NRC DRAFT SITE TECHNICAL POSITION 1.1: HYDROLOGIC TESTING STRATEGY FOR THE
BASALT WASTE ISOLATION PROJECT (BWIP)

ATTACHMENT 2

SPECIFIC BASALT WASTE ISOLATION PROJECT COMMENTS ON NUCLEAR REGULATORY COMMISSION STAFF SITE TECHNICAL POSITION

**BWIP SITE TECHNICAL POSITION NO. 1.1:
HYDROLOGIC TESTING STRATEGY
FOR THE BASALT WASTE
ISOLATION PROJECT**

Figure 2

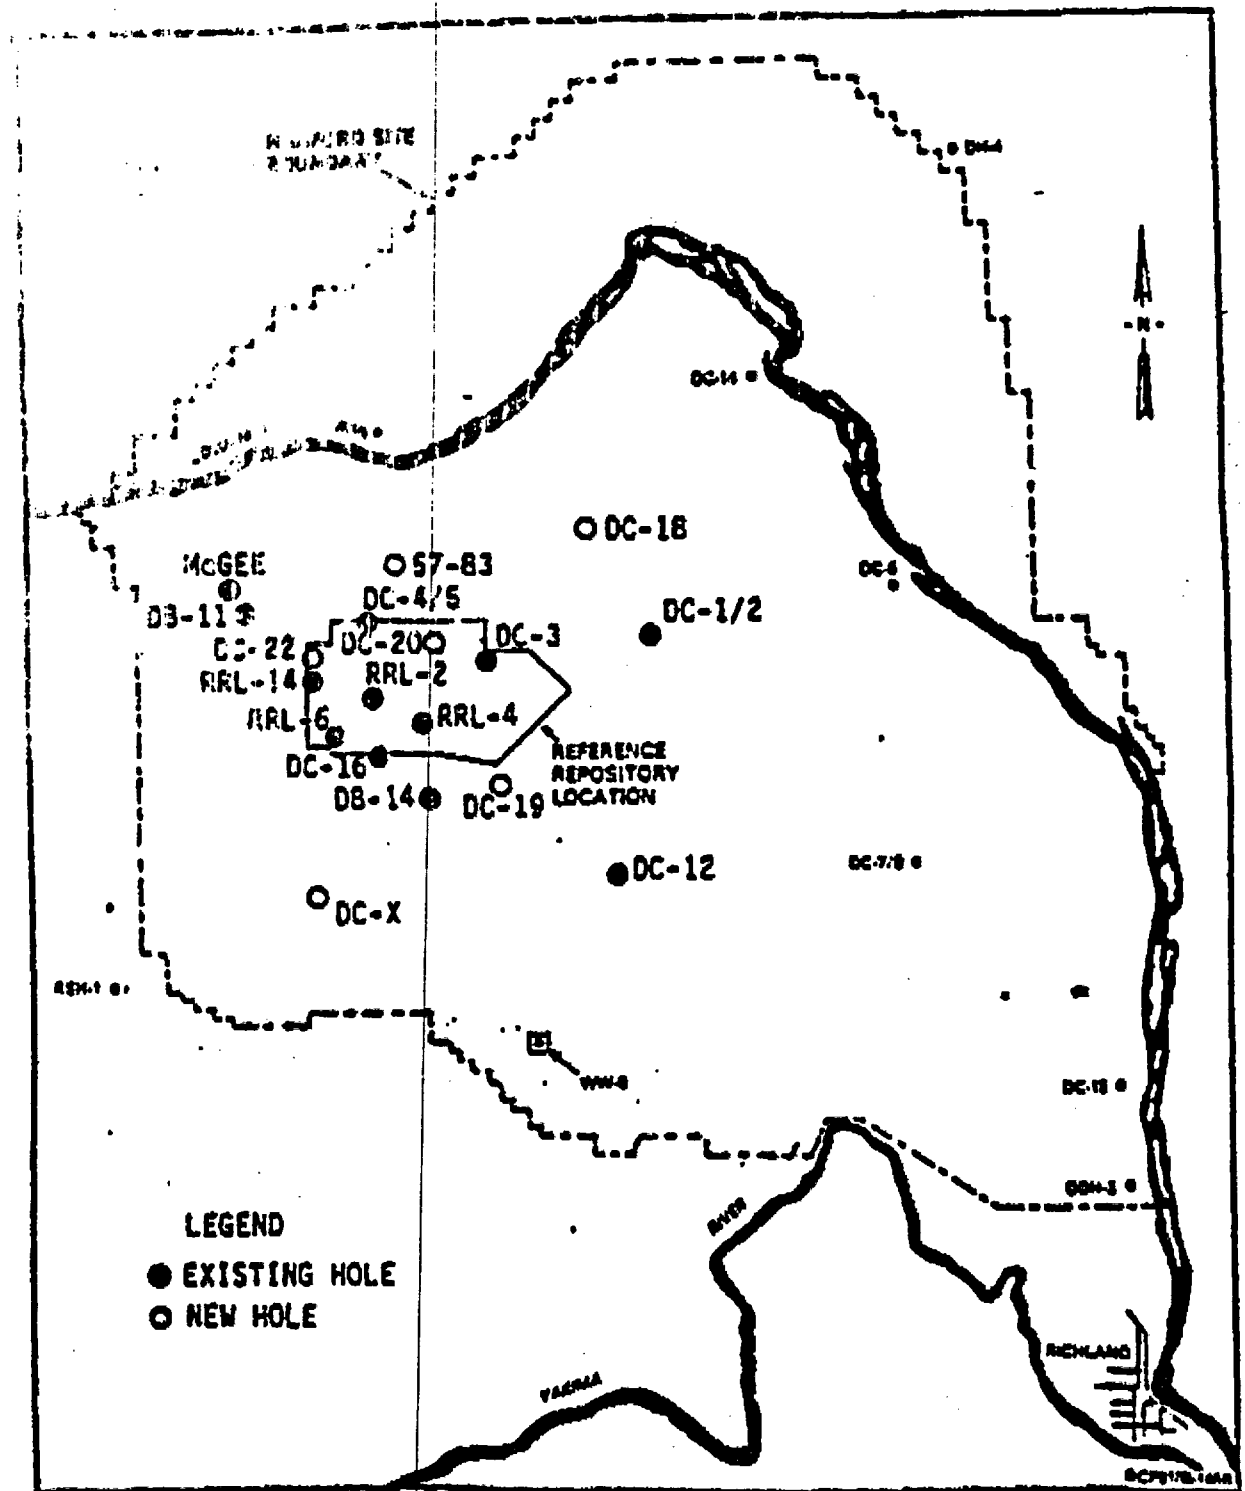
Page A-1, Paragraph 1c, Install Head and Hydrochemistry Monitoring System

This paragraph suggests that hydrochemistry samples be taken at the same time that a groundwater level baseline is being established. It also suggests specific boreholes and borehole completions to be included in the monitoring network. The BWIP program differs in the following details:

- o Hydrochemistry sampling is scheduled to be performed after a groundwater-level baseline is established because large water withdrawals which could disturb the baseline are required to obtain high quality water samples.

- o The borehole network being implemented by the BWIP differs in the following aspects:
 - DC-18 and 57-83 (now DC-23) have been delayed for budget reasons

- DC-X to the south is not in the present BWIP program
 - Multi-level measuring device development has been delayed for budget reasons
 - DC-19, -20, and -22 have been completed as nested piezometers

- DC-3 cannot be used for multi-level measurements because it is cased to the Umtanum flow interior and the borehole is open only to the flow below the Umtanum

- Individual flow tops have been selected as test intervals. Selected zones will be monitored in other boreholes (RRL-2, RRL-6, RRL-14, DC-16, DC-4 and DC-5) using conventional bridge-plug, straddle and multi-level test systems as appropriate, instead of relying solely on multi-level systems.

- Screenholes near the Reference Repository Location (RRL) which are open to more than one of the intervals monitored by DC-19, -20 and -22 have been configured to hydraulically separate the monitored intervals instead of being left as a composite.
